UNITED STATES DEPARTMENT OF THE INTERIOR BUREAU OF LAND MANAGEMENT

7. If Unit or CA. Agreement Designation	
1. Type of Well	0	
Other Coal Name of Operator	seam	8. Well, Name and Non
•	ATTN: J.L.Hampton	Trigg Fed. Gas Com
Amoco Production Company	9. API Well No.

P. O. Box 800 Denver,	Colorado 90201	
4 Location of Well (Footige, Sec., I., R., M., or Survey I	Colorado 80201	10 Field and Pool, or Exploratory Area
		Basin Fruitland Coa
2240' FSL, 865' FWL, NW/	Sw Sec. 25, T31N-R9W	11. County or Parish, State

•	San Juan, New Mexic
11. CHECK APPROPRIATE BOX	(s) TO INDICATE NATURE OF NOTICE, RE	
TYPE OF SUBMISSION		
	TYPE OF ACT	ION
Notice of Intent	Abandonment	Change of Plans
Subsequent Report	Recompleuon	New Construction
steryddin report	Plugging Back	Non-Routine Fracturing
Funal Abandonment Nouce	Casing Repair	Water Shut-Off
	Altering Casing	Conversion to Injection
	Other	ults of multiple completion on Well Completion of
13 Describe Proposed or Completed Operations (Clearly state a	Kecompletion Ren	on and Log form 1
live apparitace locations and thereard and time vetting	Recompletion Rej Il pertinent details, and give pertinent dates, including estimated date of st call depths for al

BLOWOUT PREVENTER HOOKUP

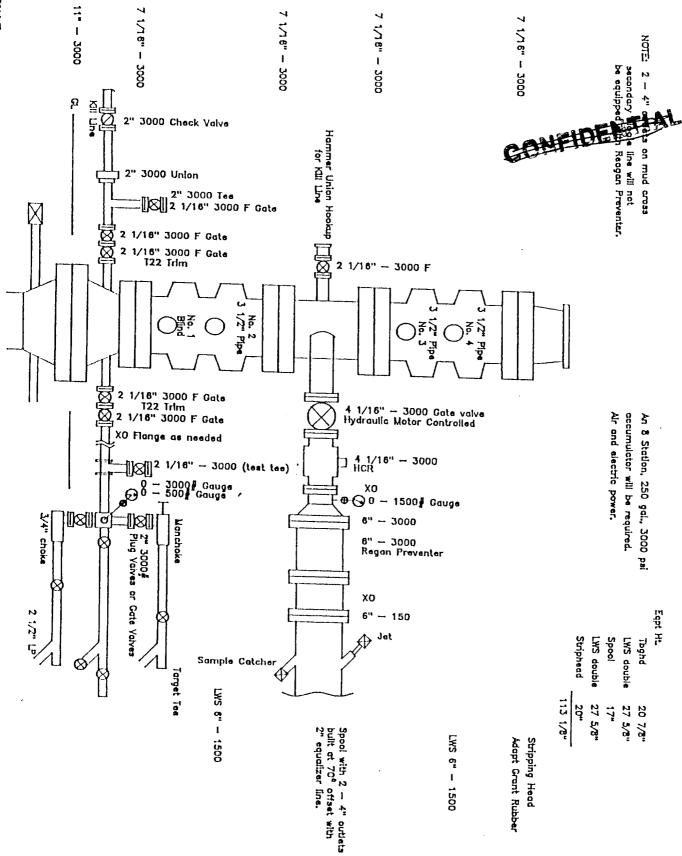
Prior to drilling below intermediate casing, a modified two (2) double ram pressure control equipment system will be installed. This system is designed for Fruitland Coal formation interval drilling with air and water. A service until will typically be used to drill this interval, and the wellbore will be completed as an uncased open hole if commercial productivity is established. If not, the wellbore will be cased and cemented with a 4 1/2" contingency liner. Based upon maximum surface pressure criteria, 2000 PSI equipment is required. However, as stated above, 3000 PSI working pressure equipment will typically be utilized. The No. 3 pipe ram in Exhibit No. 2 will be 4 3/4" if 4 3/4" drill collars are run in the bottom hole assembly.

6" nominal, 3000 PSI Two (2) double ram preventers (see Exhibit No. 2 - BOPE)
